#### APPEAL SUMMARY

<b>Appeal ID:</b> 23807	<b>Project Address:</b> 1634 SW Alder St
<b>Hearing Date:</b> 6/10/20	<b>Appellant Name:</b> Charlie Baxter
<b>Case No.:</b> B-015	<b>Appellant Phone:</b> 5034457369
<b>Appeal Type:</b> Building	<b>Plans Examiner/Inspector:</b> Crystle Cowen
<b>Project Type:</b> commercial	<b>Stories:</b> 7 <b>Occupancy:</b> A, B, R-2, S-1, S-2 <b>Construction Type:</b> I-A, III-B
<b>Building/Business Name:</b> Alta Centric Apartments	<b>Fire Sprinklers:</b> Yes - Throughout
<b>Appeal Involves:</b> Erection of a new structure	<b>LUR or Permit Application No.:</b> 19-245419-LU
<b>Plan Submitted Option:</b> pdf [File 1] [File 2] [File 3] [File 4] [File 5] [File 6]	<b>Proposed use:</b> Multi-Family Apartments

## APPEAL DECISION

## FIBER CEMENT SIDING

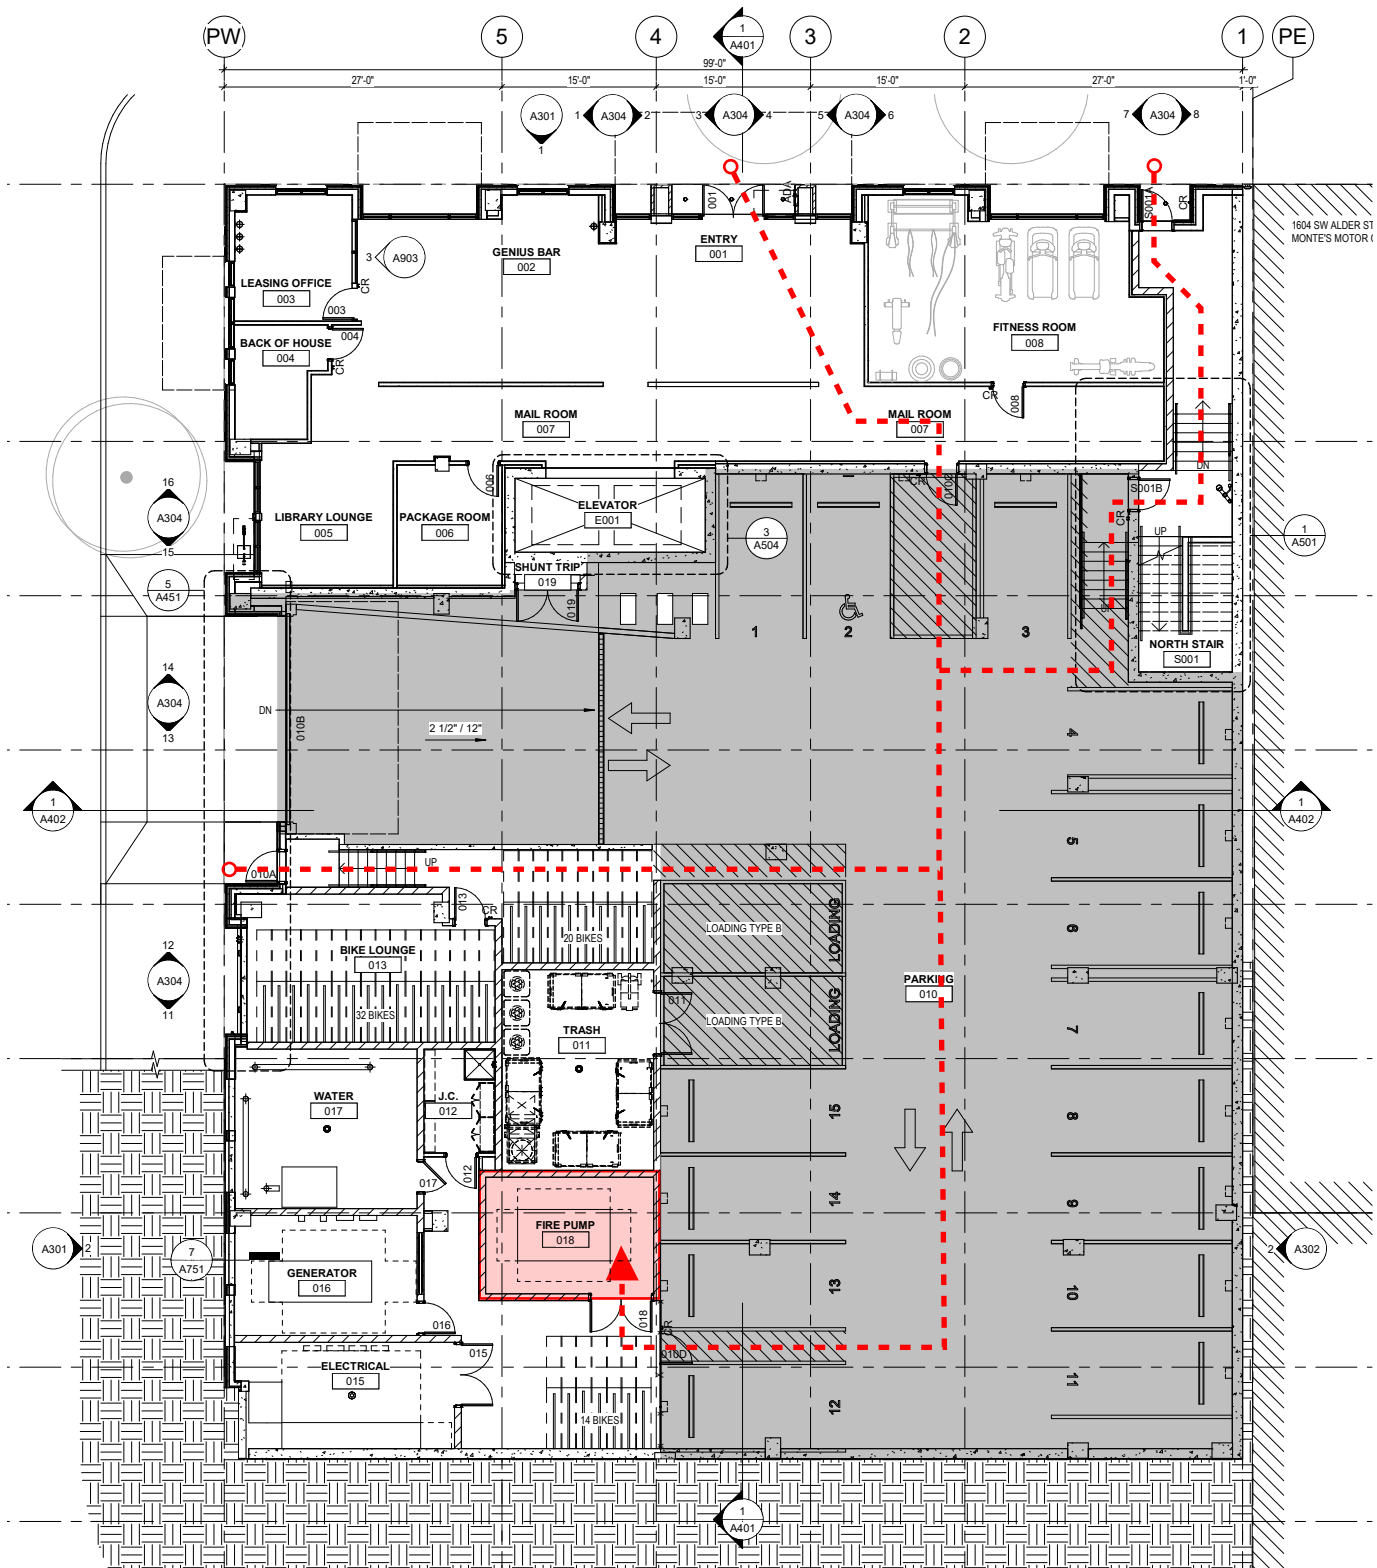
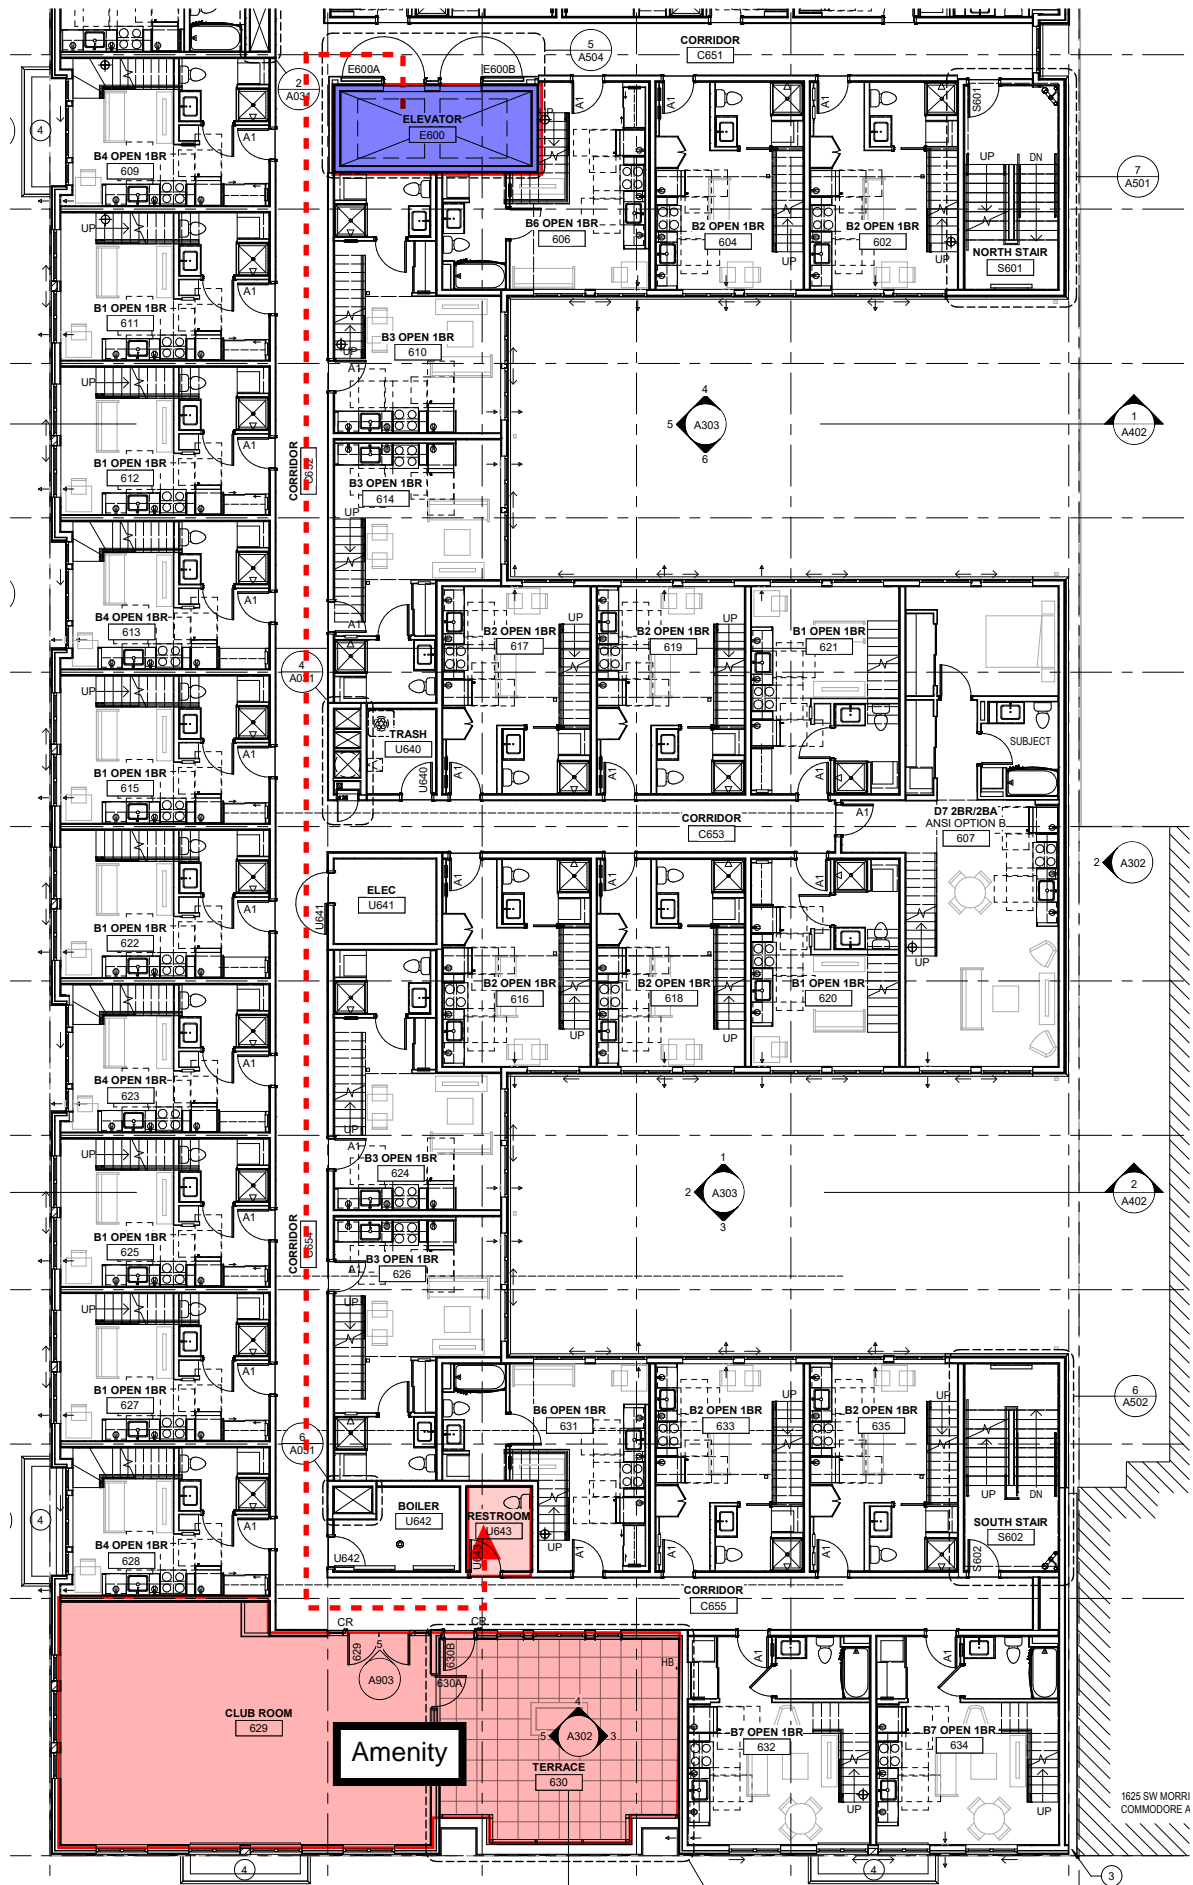
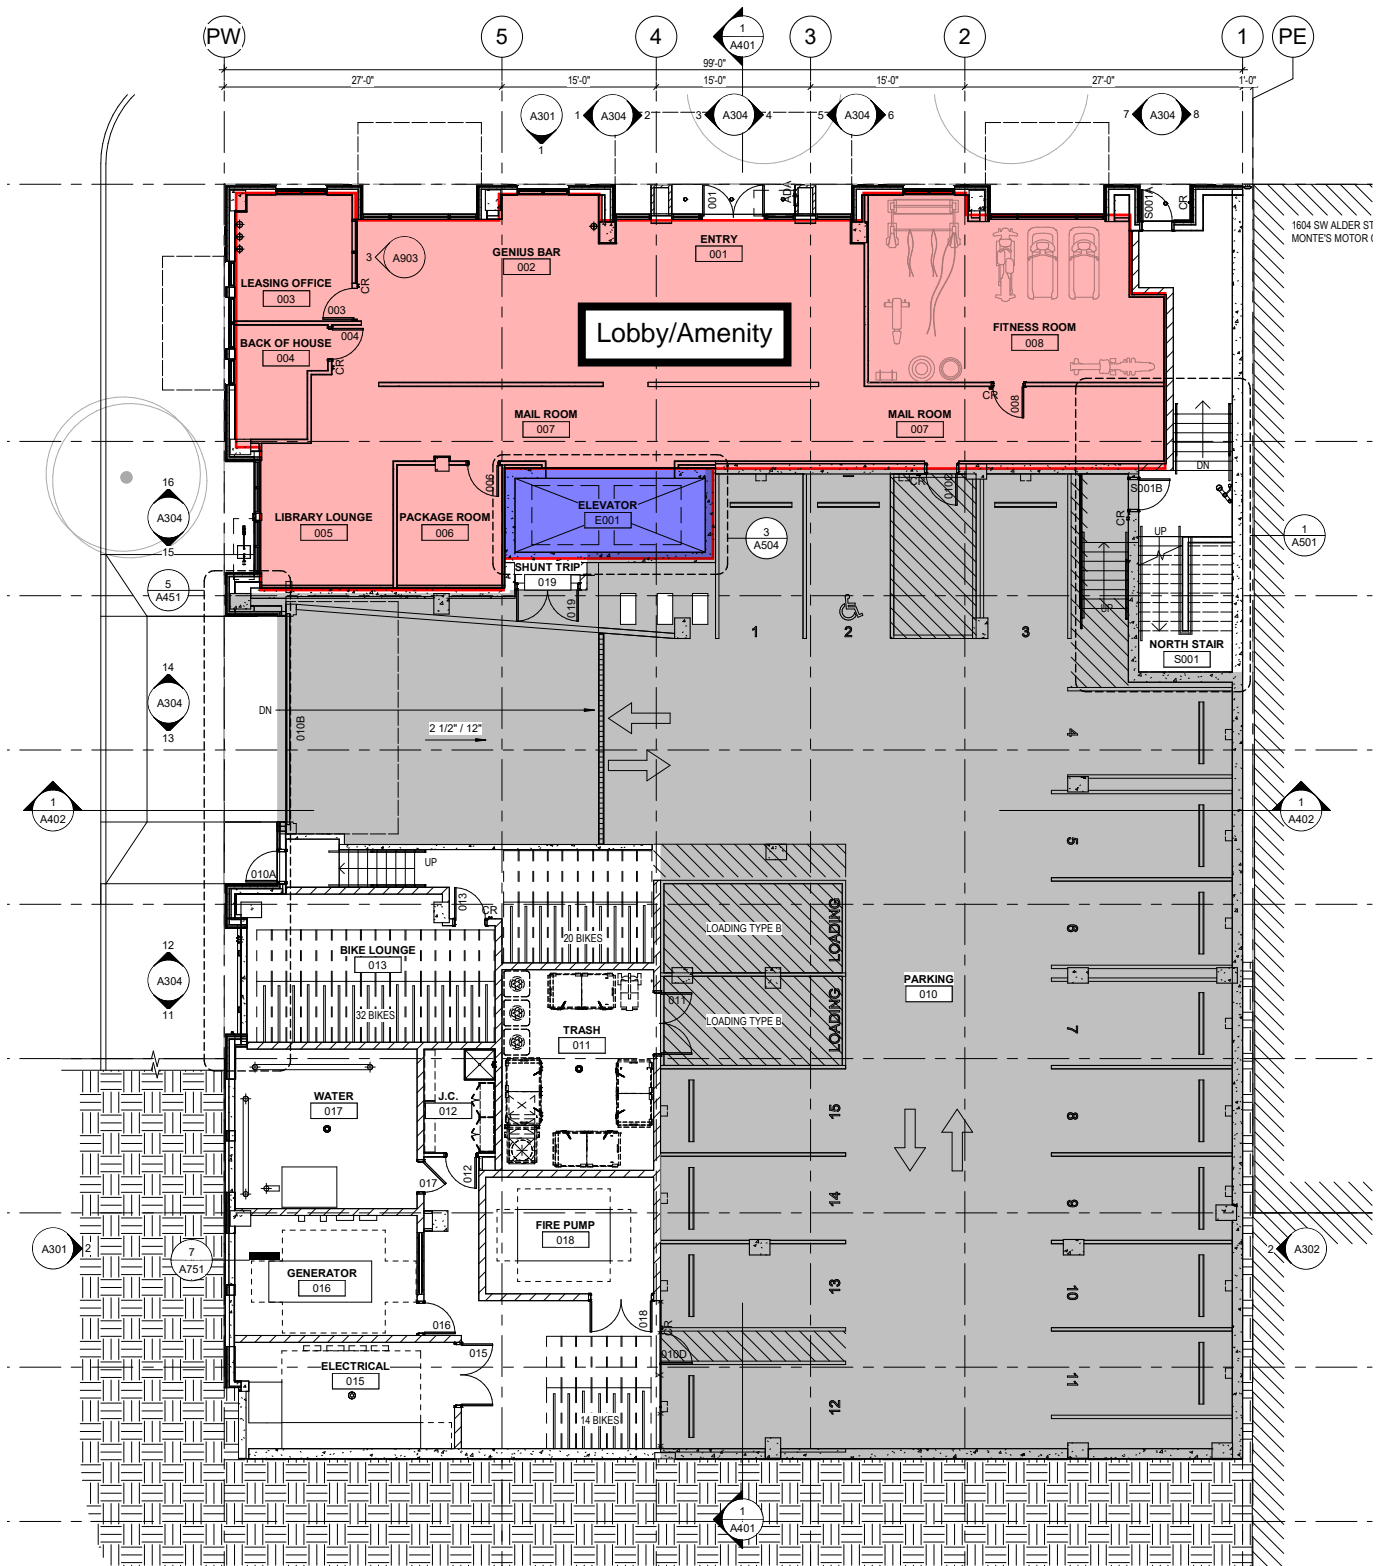
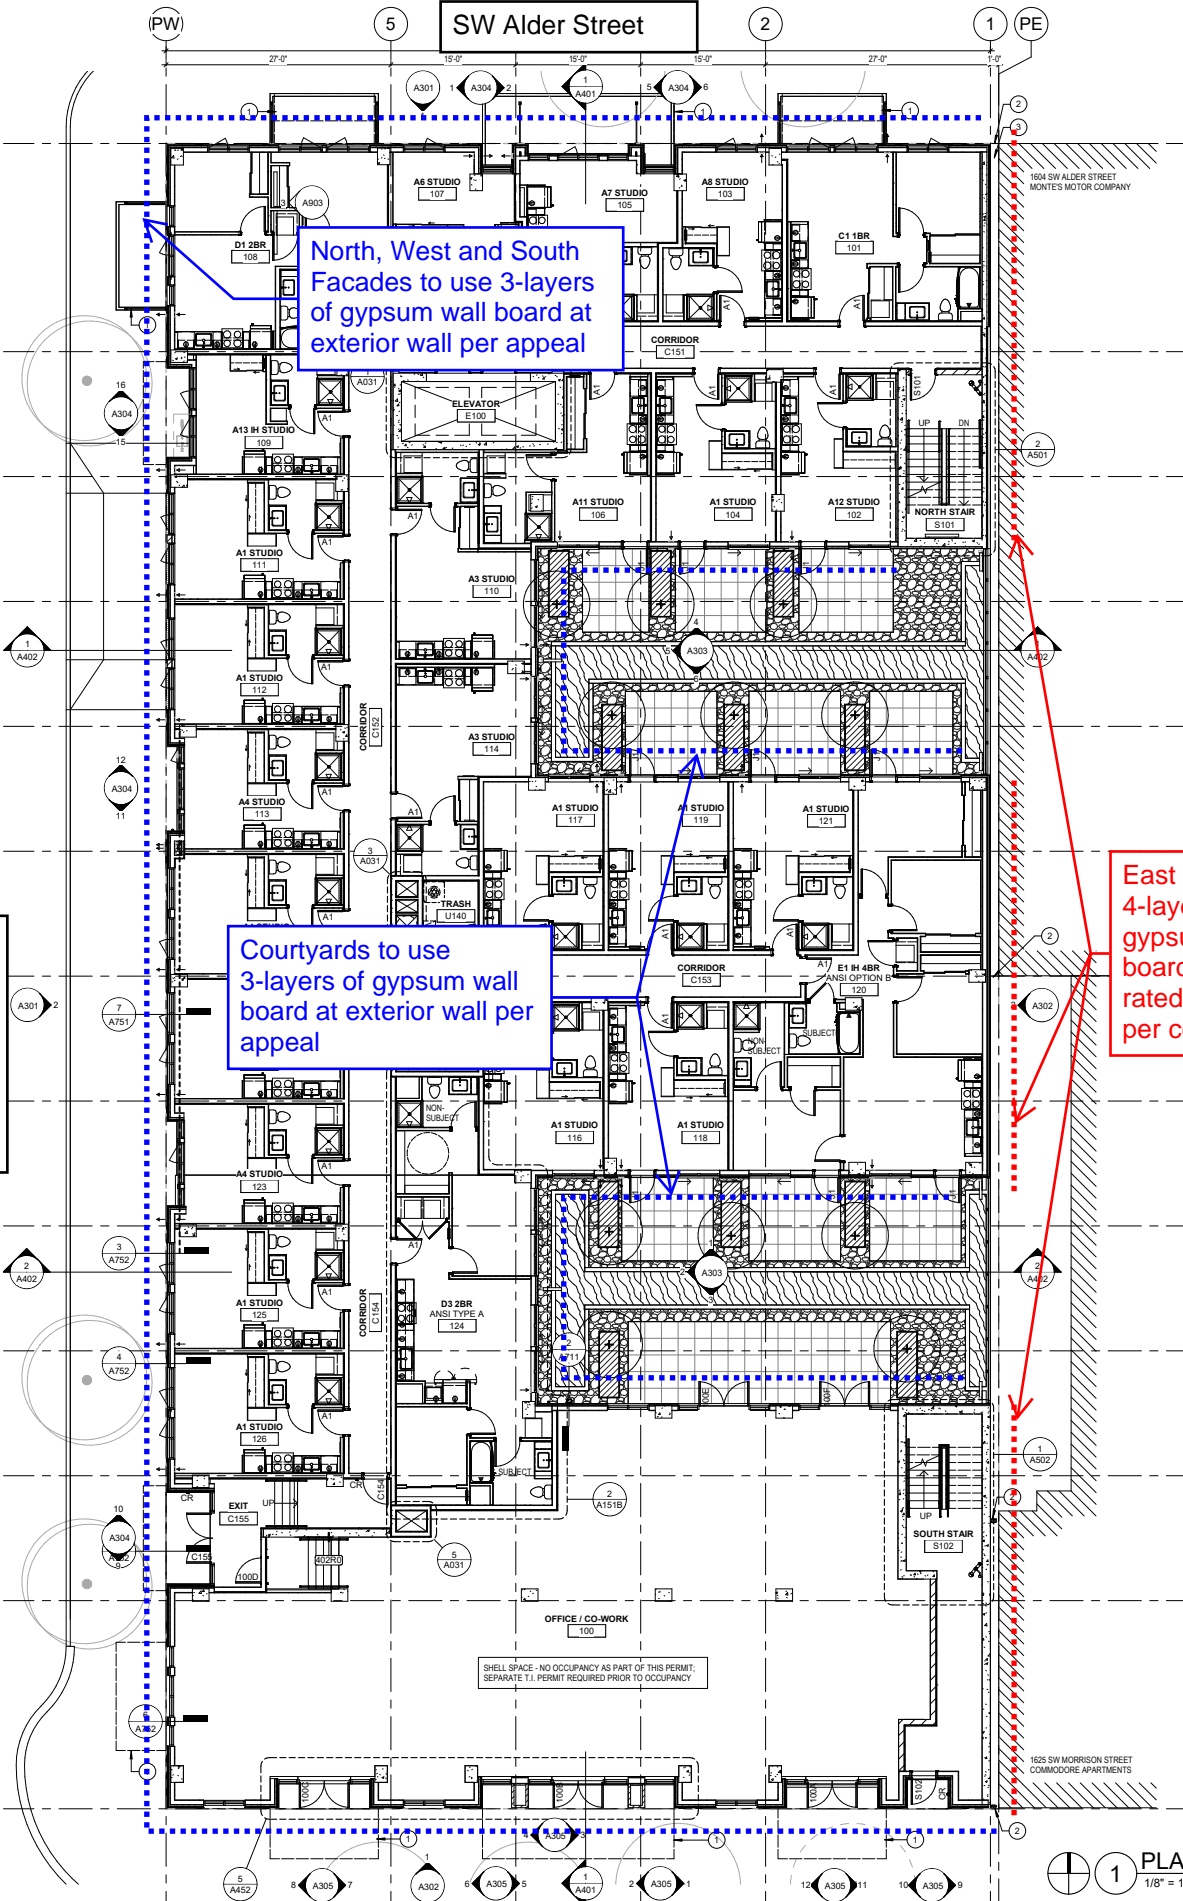
<b>Code Section</b>	OSSC 2019 section 703.2
<b>Requires</b>	<p>OSSC 2019 section 703.2 The fire-resistance rating of building elements, components, and assemblies shall be determined in accordance with test procedures set forth in ASTM E119 or UL 263 or in accordance with Section 703.3.</p> <p>OSSC 2019 section 705.5 exterior wall assemblies with a fire separation distance greater than 10 feet may be rated for fire exposure from the interior side only.</p>
<b>Code Modification or Alternate Requested</b>	3 Layers of gypsum wall board at exterior walls with greater than 10 feet of fire separation
<b>Proposed Design</b>	In exterior wall locations in the Type IIIB construction with a fire separation distance greater than 10 feet (see Exhibit 3) the project proposes a non-combustible exterior wall assembly consisting of thin brick masonry, or fiber cement siding, metal furring, weather resistive barrier, and one layer of 5/8" fire rated exterior gypsum sheathing or on the exterior side of 2x6 fire-retardant treated wood stud framing and two layers of 5/8" fire-rated gypsum board on the interior side, see Exhibits 1-2 for assemblies. Proposed assemblies are based on the City of Portland Type III Construction - OSSC/6/#4 Code Guide, section 1.b. Documents submitted for permit will identify specific wall assemblies to be used at all locations.

<b>Reason for alternative</b>	<p>There are no tested assemblies listed in the Gypsum Association Manual or UL Manual rated for 2 hour fire exposure from the interior side only.</p> <p>Per OSSC 2014 Section 104.11 the Building Official is permitted to approve proposed designs deemed satisfactory and compliant with the intent of the provisions of the building code.</p>

We conclude the proposed design meets the requirements of section 705.5 and exceeds the fire protection requirement in the city code guide and intent of the building code by providing two layers of 5/8" fire-rated gypsum board on the interior side to achieve the required 2 hour fire protection with the added protection of fire retardant treated lumber in the load bearing exterior wall framing and non-combustible exterior finishes.

**1. Alternate 2 hour fire rated exterior wall detail as described in Condition 1b. of the Type III Code Guide: Granted as proposed.**

North, West and South  
Facades to use 3-layers  
of gypsum wall board at  
exterior wall per appeal

Courtyards to use  
3-layers of gypsum wall  
board at exterior wall per  
appeal

East facade to use  
4-layers of  
gypsum wall  
board or 2 hour  
rated assembly  
per code

1 PLAN - LEVEL 01  
1/8" = 1'-0"

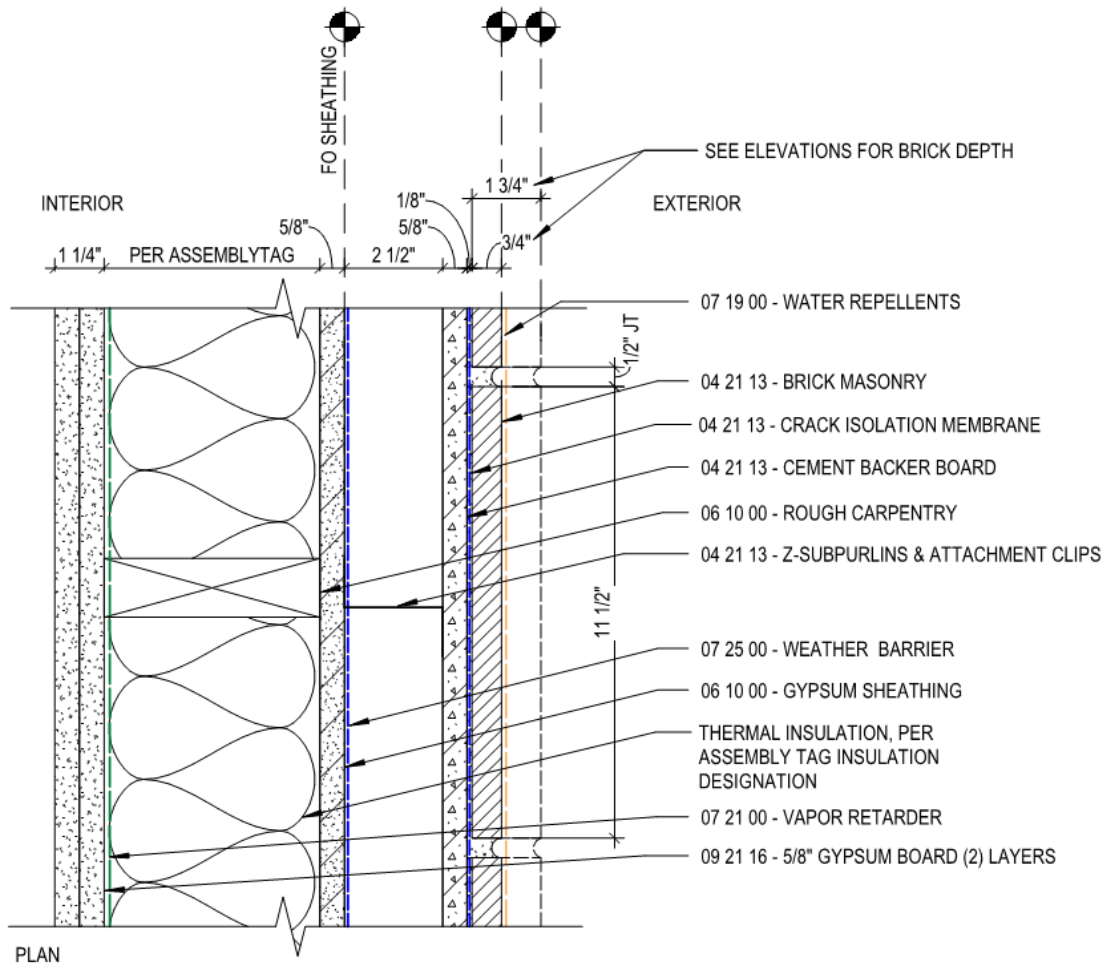
<b>Code Section</b>	2019 NFPA 20
<b>Requires</b>	<p>4.12.2.1.1 Fire pump rooms not directly accessible from the outside shall be accessible through an enclosed passageway from an enclosed stairway or exterior exit.</p> <p>4.12.2.1.2 The enclosed passageway shall have a fire-resistance rating not less than the fire-resistance rating of the fire pump room</p>
<b>Code Modification or Alternate Requested</b>	Omission of exit passageway connecting fire pump room to exit
<b>Proposed Design</b>	<p>See Exhibit 6 - Fire Pump Room Access for more information:</p> <p>The proposed design provides a 2 hour fire rated enclosure around the fire pump room located at grade directly off the parking area. Access to the fire pump room in case of problem with automatic operation is provided through multiple access points throughout the ground floor providing equivalent access.</p> <p>Additional fire protection is provided by a 2 hour separation between the garage and other areas of the building.</p>

**Reason for alternative** The fire pump room is centrally located with access paths as shown in the exhibit. Initially, in earlier renditions it was located where the bike lounge is currently shown (room 013), but due to the city's "active storefront" requirement during Design Review we were required to displace the fire pump room with a bike lounge, which is considered "active". The old location for the pump room would have been ideal to provide a rated passageway or direct access to the exterior. But this move landlocks the fire pump room.

**3. Omission of exit passageway connecting fire pump room to exit: Granted as proposed.**  
**Appellant may contact John Butler (503 823-7339) or e-mail at [John.Butler@portlandoregon.gov](mailto:John.Butler@portlandoregon.gov) with questions.**
